SOUTH COAST AIR QUALITY MANAGEMENT DISTRICT

# Comments and Responses to Comments

## 2016 AIR QUALITY MANAGEMENT PLAN

March 2017

**Figure 1.** Observed and modeled ozone Design Value (DV) trends at Crestline using the 3-yr DV (top) and 5-yr DV (bottom), and the draft 2016 AQMP CMAQ 2012 modeling platform using observed trends through 2016 ozone season data.

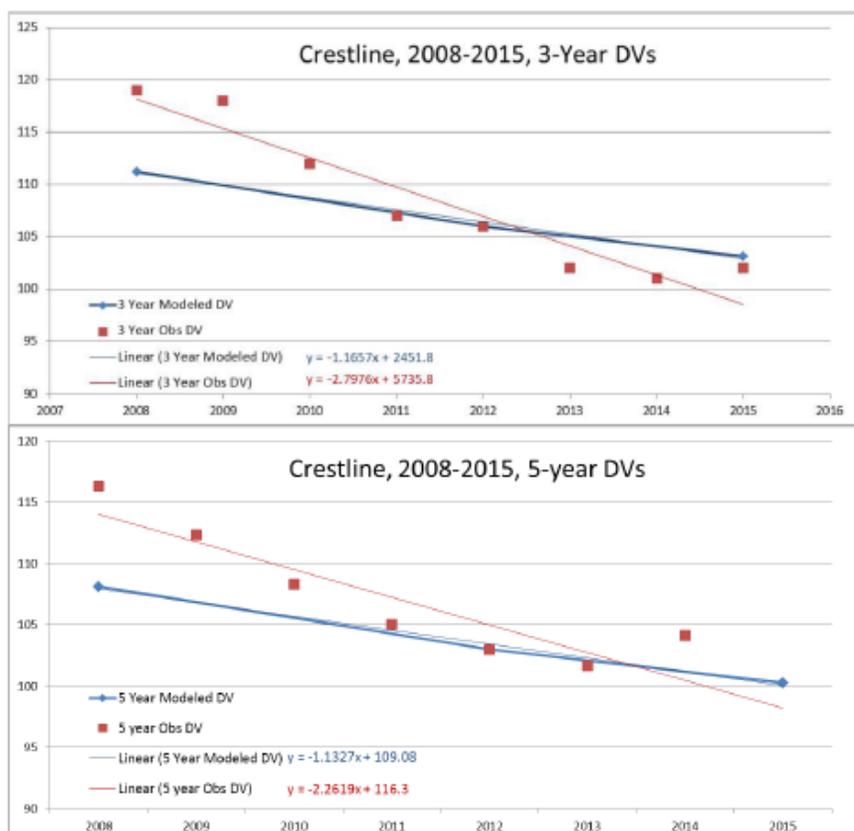
Figure 1 (below) presents Ramboll’s dynamic model evaluation comparing observed ozone trends at Crestline, which generally corresponds to the Basin-wide maximum ozone design value, with the 2016 AQMP CMAQ 2012 modeling database for the period of 2008 to 2014/2015. Even when including the unusually high observed ozone level from 2016, the rate of the modeled ozone reduction trend using the 2016 AQMP CMAQ 2012 is still at least a factor of 2 lower than the observed trend.

The results of that dynamic evaluation, not extrapolation, are significant. At the Crestline DV site (*see* Figure 1 above), the observed rate of ozone reductions is almost twice as high as the modeled rate, and the basin-wide rate of 5-yr DV reductions is over 50% faster than the modeled rate. This holds even when using the unusually high 2016 ozone season as the ending year anchor-point in the observed ozone trend.

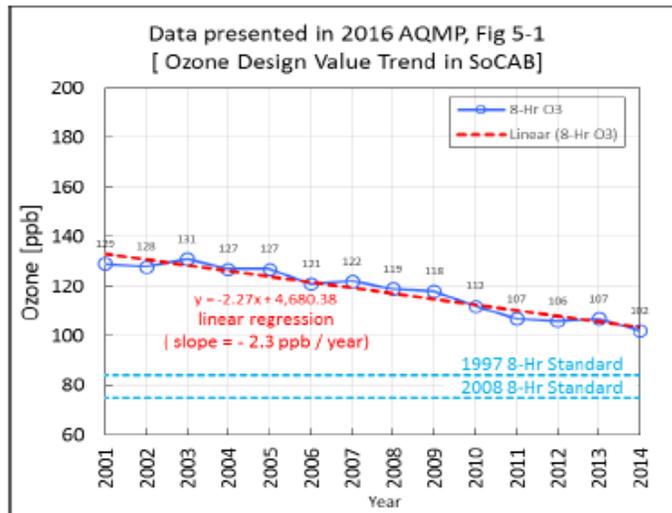
Despite Staff's recent editing, the fact remains that the measured 8-hour ozone design value in the SoCAB has been declining at a rate of 2.3 ppb per year over the 14-year period from 2001 to 2014. At that same rate, the ozone level at Crestline (which was 101 ppb in 2014) would be 80 ppb in 2023 and 62 ppb in 2031. That rate of decline would result in an ozone level that would be well below the targeted attainment level in 2031 (of 75 ppb) and in attainment with the applicable NAAQS in 2023 (i.e., a DV less than 85 ppb), without any additional control measures. While expecting a constant linear 2.3 ppb/year reduction between 2012 and 2023 may not be reasonable, a rate of 0.73 is arguably even more unlikely based on the analyzed data to date.

Figure 5-1 from the Final Draft AQMP (p. 5-4) shows the ozone DV trend, and compares it against the 1997 8-hr standard (84 ppb when accounting for allowable rounding). Figure 5-1 is reproduced below. For clarity, we have added labels to each data point. We have also included a linear regression through the data (which yields the estimated 14-year ozone-reduction slope of -2.3 ppb/year). It is interesting to note that the DV during those 14 years was set by Crestline each year, except in 2013. In that year, Crestline's DV was 102 ppb while Redlands' DV was 107 ppb. The ozone DV rate of reduction for Crestline during that time period was -2.42 ppb/year.

108-4

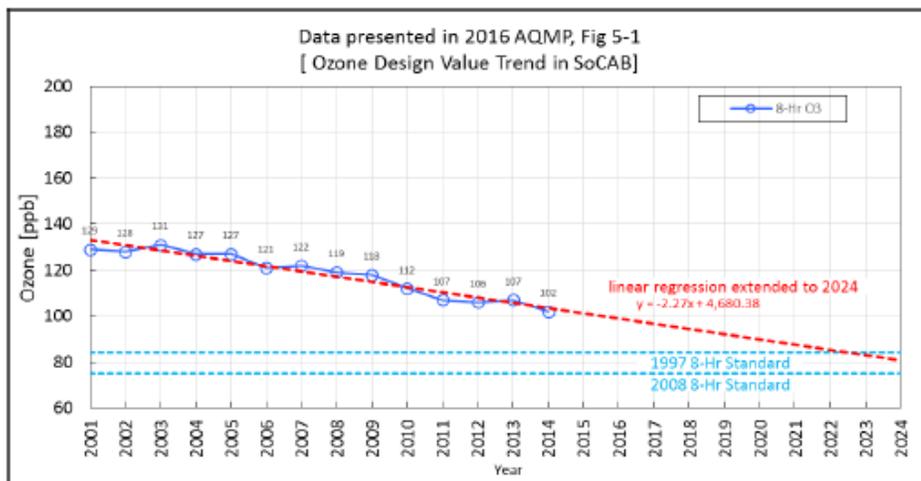
For additional insight, the same data shown are below, extended to 2024, the year when attainment with the 1997 8-hr ozone standard of 84 ppb must be demonstrated. When the established trend is extended to 2024, again simply for illustrative purposes (not for dynamic evaluation purposes), the DV appears to meet the 1997 8-hr standard on time.

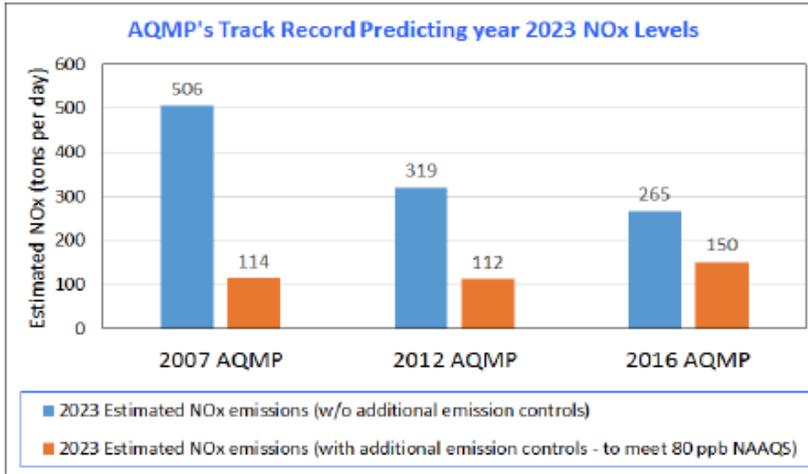
A section of Chapter 3 of the Final Draft AQMP, entitled “Uncertainties in the Emissions Inventory” (p. 3-9), stresses the importance of an accurate inventory and describes general improvements to emissions models. However, the District fails to include any quantitative uncertainty estimates for the baseline or future-year emissions estimates. Similarly, the District does not discuss or attempt to quantify the uncertainties associated with the methods and datasets used to prepare the emissions estimates for air quality modeling (e.g., spatial and temporal allocation, and chemical speciation).

108-5

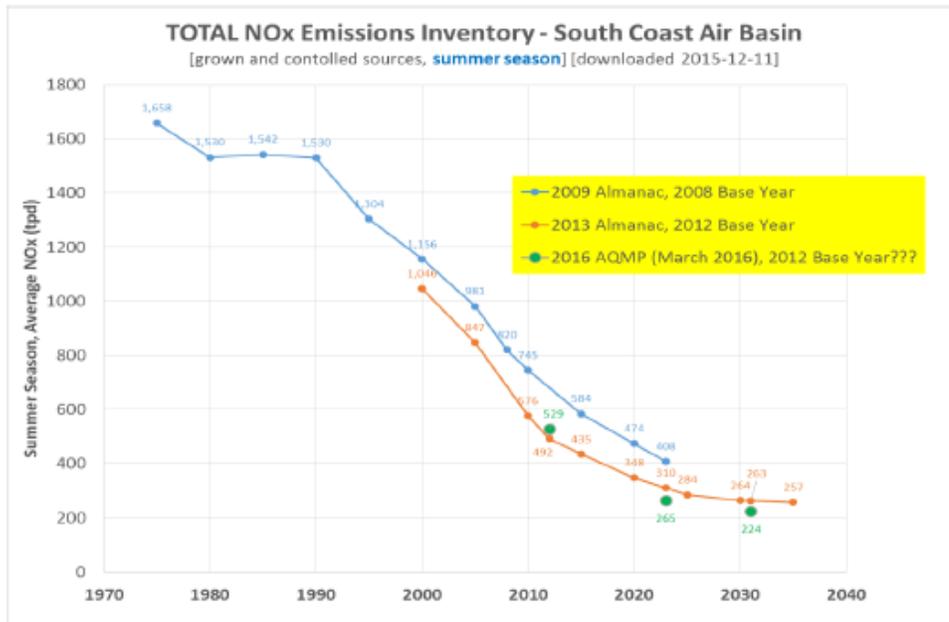
At page 5-8 of the Final Draft AQMP, the District states: "... Lower 2023 baseline VOC and NO<sub>x</sub> emissions in the 2016 AQMP relative to the 2012 AQMP reflect the impact of ... the recession occurring between 2008 and 2010." That is not a fair statement.

Review of the 2012 AQMP reveals that the emissions inventory used for that analysis was based on the 2013 CARB Almanac. Significantly, that set of inventory numbers already appears to have accounted for the 2008-2010 recession. The figure below shows a comparison of NO<sub>x</sub> inventory values from the 2009 and 2013 Almanacs, along with the most recent NO<sub>x</sub> values used in the Draft AQMP. It is clear that the 2013 Almanac NO<sub>x</sub> emissions (which were used for the 2012 AQMP) show an "additional reduction" of NO<sub>x</sub> between the 2008 and 2010 time frame. The NO<sub>x</sub> slopes of the 2009 and 2013 Almanac values are clearly different during the recession period. Additionally, the NO<sub>x</sub> values used in the Draft AQMP (shown in green) seem to line up quite closely to those of the previous inventory. From this, it seems unjustified to attribute a significant portion of the NO<sub>x</sub> inventory changes in the 2016 AQMP model to the 2008-2010 recession.

**Figure 1. Observed and modeled ozone Design Value (DV) trends at Crestline using the 3-yr DV (top) and 5-yr DV (bottom) and the draft 2016 AQMP CMAQ 2012 modeling platform using observed trends through 2016 ozone season data.**

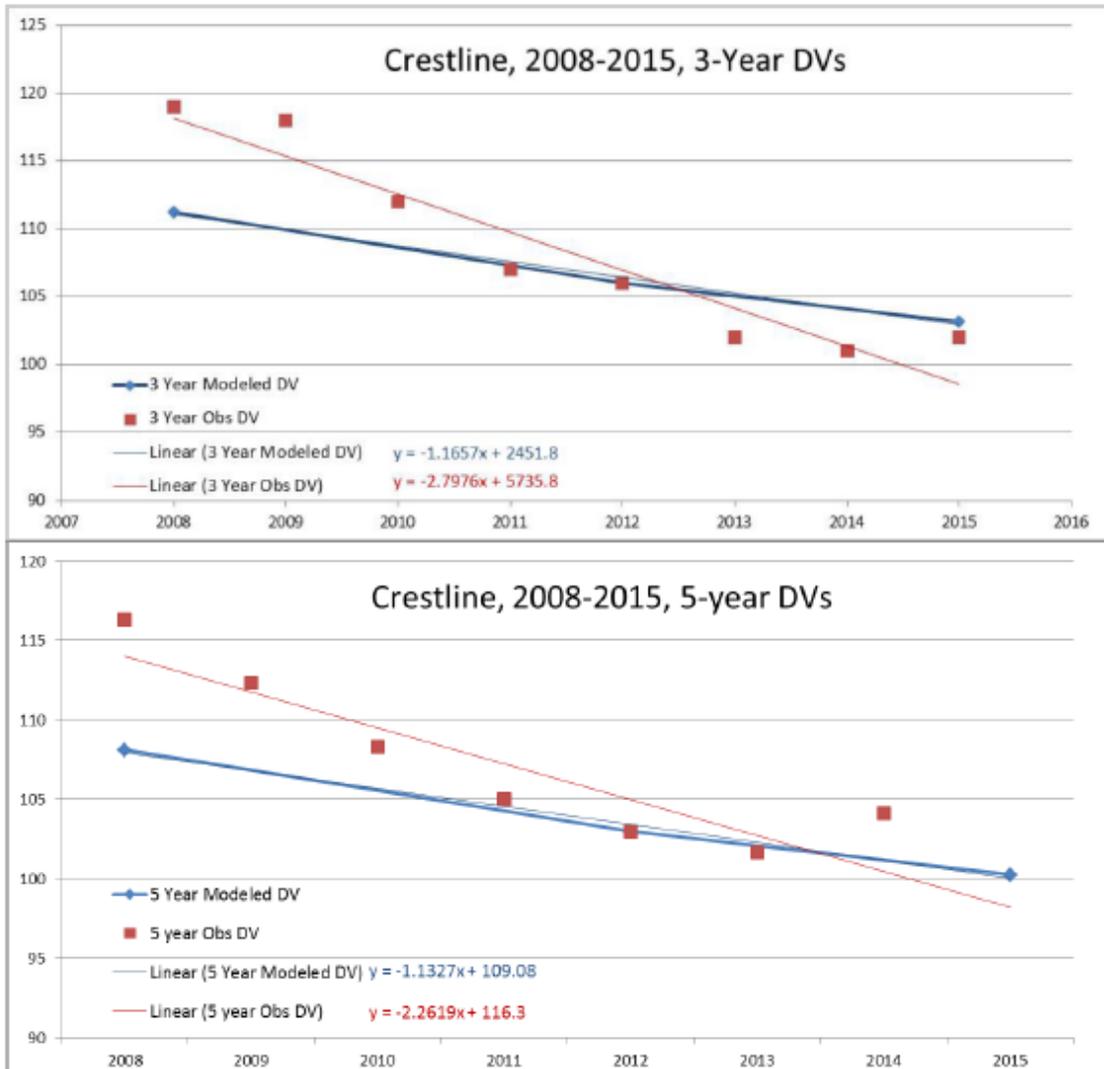
Figure 1 presents our dynamic model evaluation comparing observed ozone trends at Crestline, which corresponds to the Basin-wide ozone maximum most of the time, with the draft 2016 AQMP CMAQ 2012 modeling database for the period of 2008 to 2014/2015. This dynamic evaluation addresses SCAQMD's comments by:

- Showing the observed and modeled ozone trends using both the 3-yr DV (Figure 1, top) and 5-yr DV (Figure 1, bottom).
- Including observed ozone data from 2016 in the trends analysis (i.e., observed ozone trends end using 2015 3-year DV (2014-2016) or 2014 5-year DV (2012-2016)).
- Limiting the trends analysis between 2008 and 2014/2015 when the uncertainties associated with using 2012 spatial distribution of emissions and BCs is minimized.

The SCAQMD is correct, when including the higher observed ozone data from 2016, the observed and modeled ozone trends are closer together as shown in Table 1 below. However, even when including the unusually high observed ozone from 2016, the modeled ozone trend reduction using the 2016 AQMP CMAQ 2012 is still at least a factor of 2 or more less steep than the observed trend. Figure 1 also shows how the trends were calculated using regression equations through the available ozone data between 2008 and 2015. Note that for the 5-yr DV trends, the observed data only go through 2014, since that is the last year the observed ozone data are available for calculating the 5-yr DV (i.e., 2012-2016), whereas for the 3-yr DV the trends go through 2015 (2015 3-yr DV based on 2014-2016 data).

Figure 2. Slides No. 2 (top) and 3 (bottom) from SCAQMD's presentation Item 3b from the October 26, 2016 STMPRAG meeting (Source: SCAQMD, 2016).

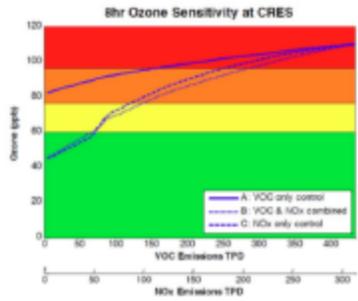
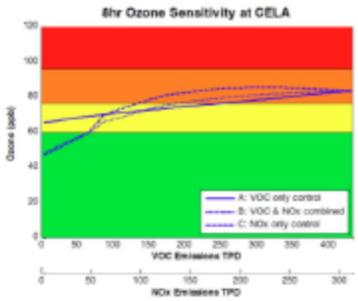
Slides number 2 and 3 from the SCAQMD STMPRAG meeting presentation are reproduced in Figure 2 below. These slides imply that our dynamic evaluation extrapolated the ozone DVs. However, our dynamic evaluation presentation never extrapolated the ozone DVs. Rather it compared historical observed ozone trends with modeled changes in ozone over different historical periods dating as far back as 1990 (2012 AQMP) or 1995 (2016 AQMP) to current (2014/2015). The comparison of the historical observed and modeled ozone trends clearly shows that the modeled rate of ozone reduction over time is significantly lower than observed. Our dynamic evaluation compares the observed ozone rate of ozone reduction over time with modeled values using linear regression equations within the 1990-2015 time periods, with no extrapolation. In the discussion below, we have included the observed 2016 ozone data in the dynamic evaluation that was not available at the time of our previous analysis.

Figure 3. Slides No. 4 (top) and 5 (bottom) from SCAQMD’s presentation Item 3b from the October 26, 2016 STMPRAG meeting (Source: SCAQMD, 2016).

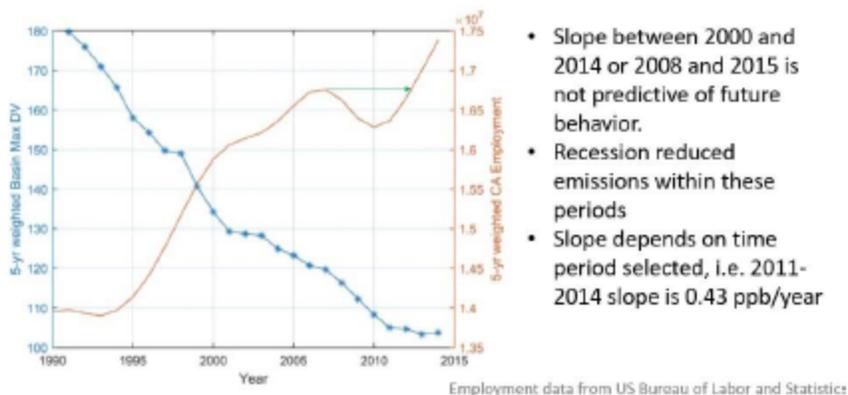
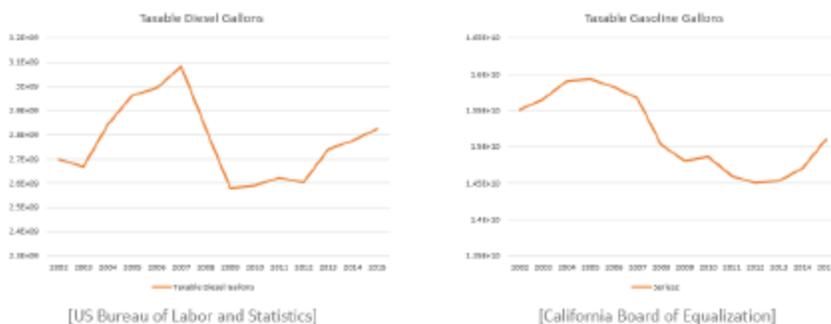
Figure 3 reproduces SCAQMD slides number 4 and 5 from the SCAQMD’s STMPRAG meeting presentation that make the point that the time window chosen for analyzing observed and modeled ozone trends can make a difference. We agree, which is why we analyzed ozone trends over several different time windows and tried to examine trends over sufficiently long periods so that they are meaningful and not unduly influenced by year-to-year variations in ozone due to meteorological variations. For example, the observed rate of ozone reductions between 1990 and 2000 was greater than in more recent years. In order for the ozone trends to have meaning, they need to be calculated over a sufficient amount of years so that year-to-year variability due to meteorology does not dominate the trends.

The following paragraphs present our response to the three bullet points in SCAQMD’s presentation slide number 4 (Figure 3, top).

Slope between 2000 and 2014 or 2008 and 2015 is not predictive of future behavior (SCAQMD slide no 4): This is not our statement; what we are demonstrating is that previous “future predictions” in AQMPs systematically underestimated ambient “future” concentration reductions from emission reductions and that the AQMP modeling databases (2012 and 2016 AQMP) do not estimate as great a rate in ozone reductions as observed when performing modeling of historical years. Our conclusion would be that there is a high probability that the current 2016 AQMP modeling would be affected by the same systematic underestimation. The CMAQ 2023 ozone projections in the 2012 AQMP has greatly understated the observed rate of

*Slope depends on time period, i.e. 2011-2014 slope is 0.43 ppb/year (SCAQMD slide no. 4):* As noted in the SCAQMD presentation, the observed 5-yr DV ozone trend over 2011-2014 period is 0.4 ppb/year as stated in SCAQMD's slide number 4 (Figure 3, top) and shown in our analysis in Figure 4c and Table 2. However, 4 data points of 5-yr DVs is not a sufficiently long time to establish a trend, especially when using the 2016 year end point that SCAQMD noted at the STMPRAG meeting was in the top 0.5% of ozone formation conducive meteorological conditions over the last 70 years (1946-2016). As shown in the 1995-2015 20-year ozone time series plot at the top panel of Figure 4a, the observed ozone reduction trend has experienced numerous shoulders of lower reduction along with steeper slopes of faster ozone reductions when looking at short time periods. For example, the observed ozone reduction trend between 1997 and 1998 was 0.7 ppb/year followed by an ozone reduction rate of 8.3 ppb/year, neither of which represents a true ozone trend due to too short of a time period for analysis.

Figure 4a. Observed and modeled 5-yr DV ozone trends using the draft 2016 AQMP CMAQ 2012 modeling database at Crestline for 1995-2015 (top) and 2000-2015 (bottom).

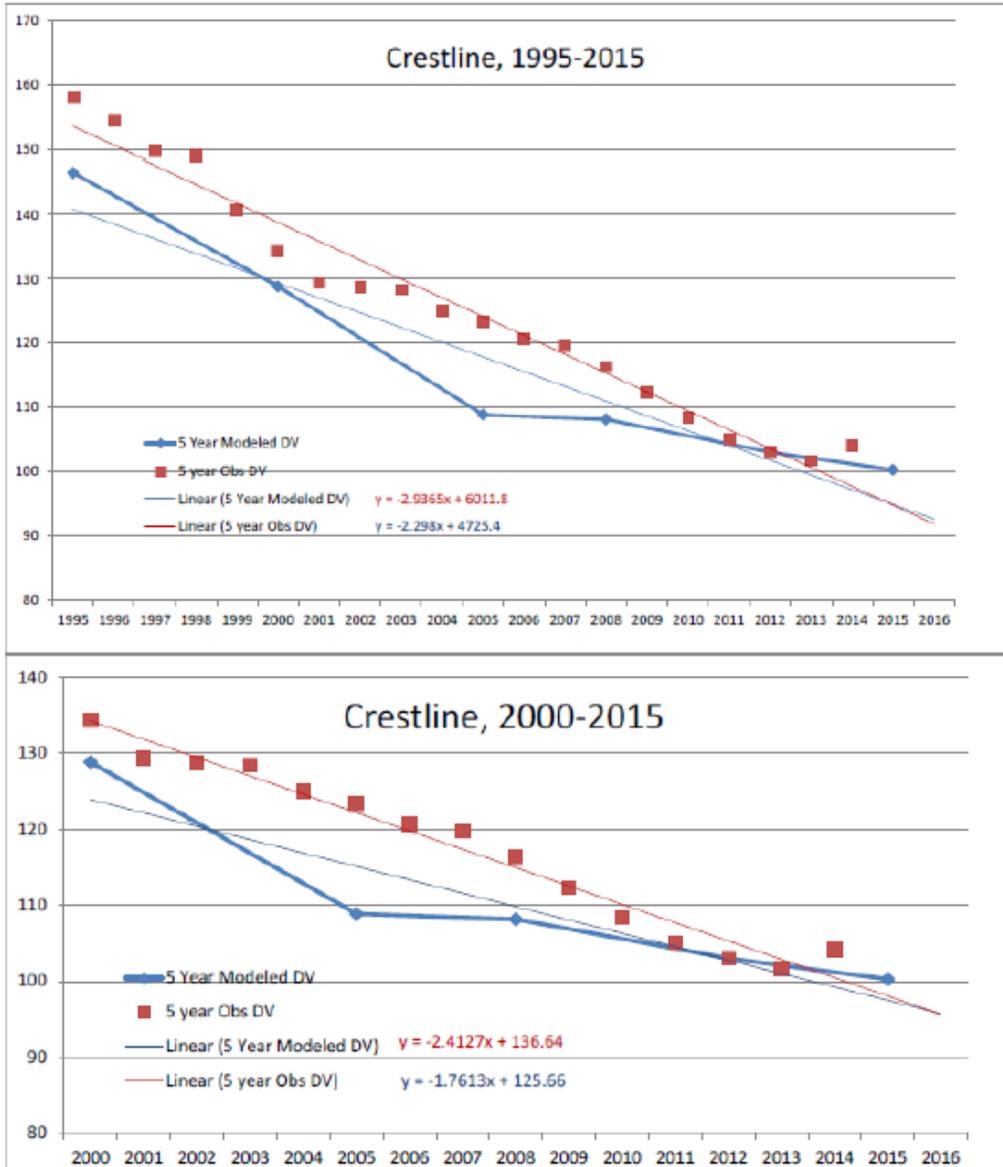
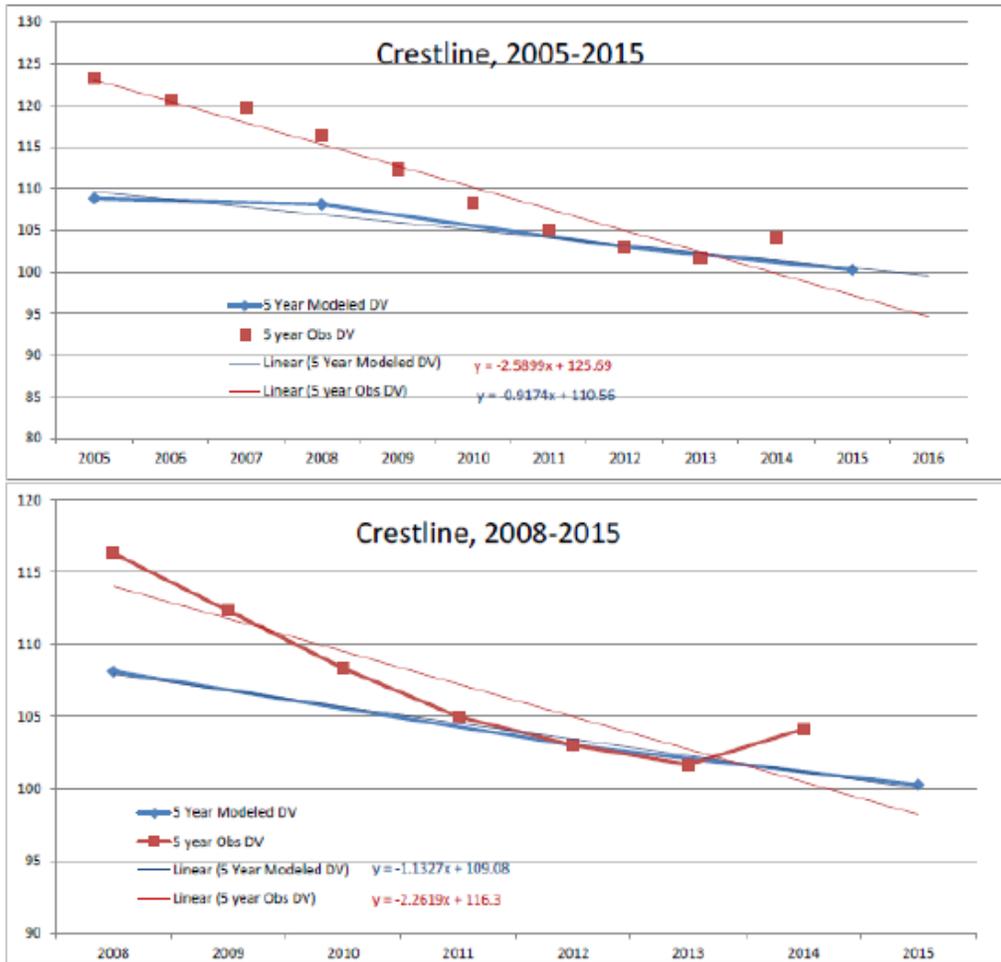
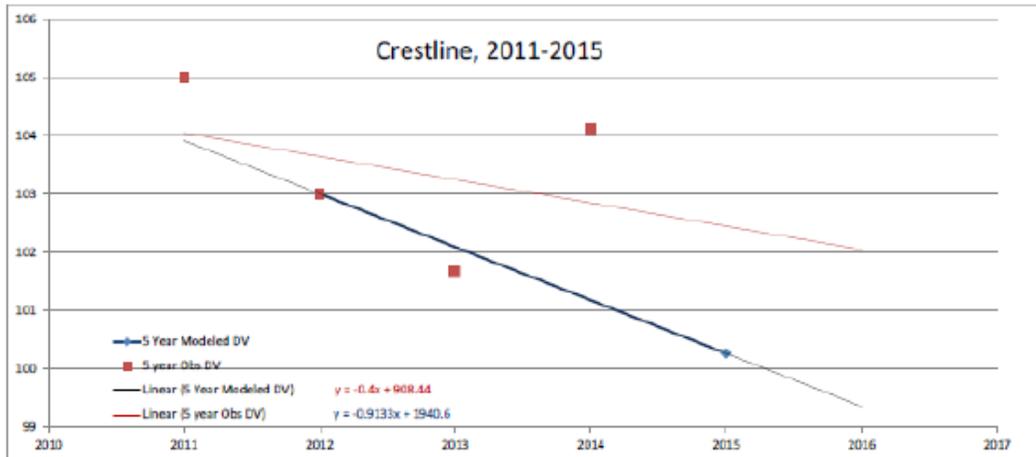
Figures 4a, 4b, and 4c display our dynamic evaluation for the draft 2016 AQMP CMAQ 2012 modeling database using the 5-yr DVs at Crestline for five different time windows ranging from 25 to 4 years in length, with the tabular summary of the observed and modeled ozone trends comparison given in Table 2. With the exception of the 2011-2015/2014 trend based on 4 data points with the end point being the 2014 5-yr DV (2012-2016) that is highly influenced by the unusually high 2016 ozone levels (Figure 4c), the rate of the observed ozone reduction is 1.3 to 2.8 times faster than modeled. The last time window, from 2011-2015/2014 not only is highly influenced by the unusual 2016 ozone levels, but does not provide enough time ( 4 years of 5-yr DV data) to establish a “trend” that can be used for robust comparisons.

Figure 5. Slide NO. 6 from SCAQMD's presentation Item 3b from the October 26, 2016 STMPRAG meeting (Source: SCAQMD, 2016).

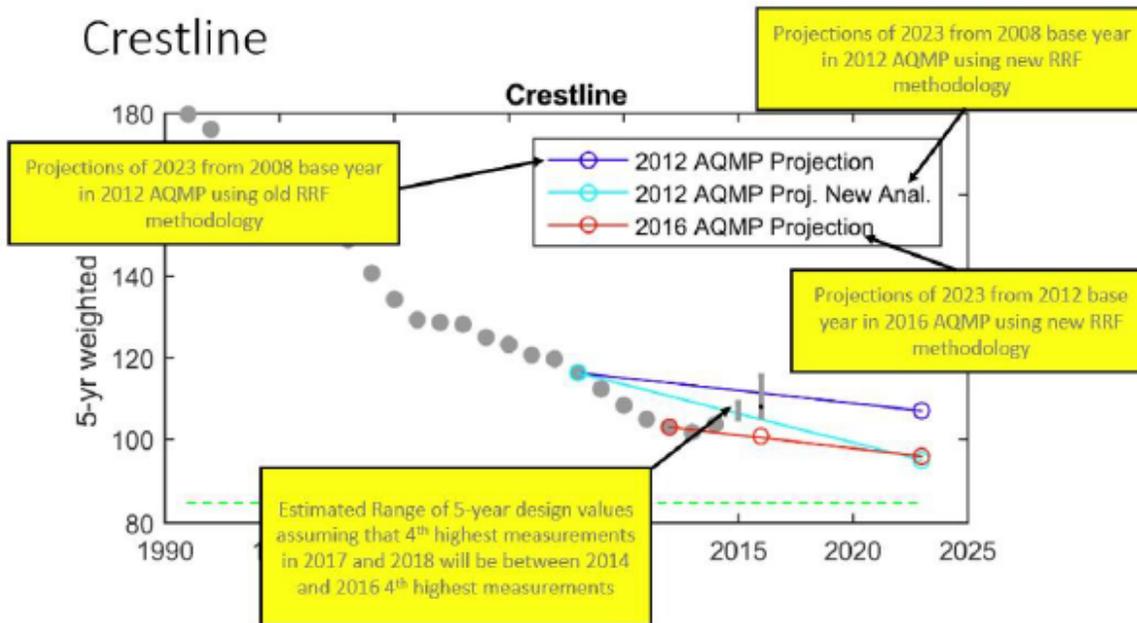
Slides numbered 6, 7 and 8 from the STMPRAG SCAQMD presentation show 2023 ozone projections using the current 2007 and draft 2014 ozone guidance, with slide number 6 reproduced in Figure 5 below showing the results for Crestline. As expected, using the 2012 AQMP CMAQ modeling results for 2008 and 2023, the projected 2023 ozone DV using the new guidance is lower than using the old guidance. This is consistent with our modeling results that are shown in Figure 6, which show the 2023 projected ozone DV using the 2012 AQMP modeling results to be 107.0 ppb using the old and 98.3 ppb using the new RRF guidance. That is, the rate of ozone reduction between 2008 and 2023 using the 2012 AQMP modeling results is 0.6 ppb/year using the old and 1.2 ppb/year using the new EPA guidance. However, that is still a modeled rate of ozone reduction (1.2 ppb/year) that is almost a factor of two lower than observed ozone reduction between 2008 and 2014 (2.3 ppb, see Table 2).
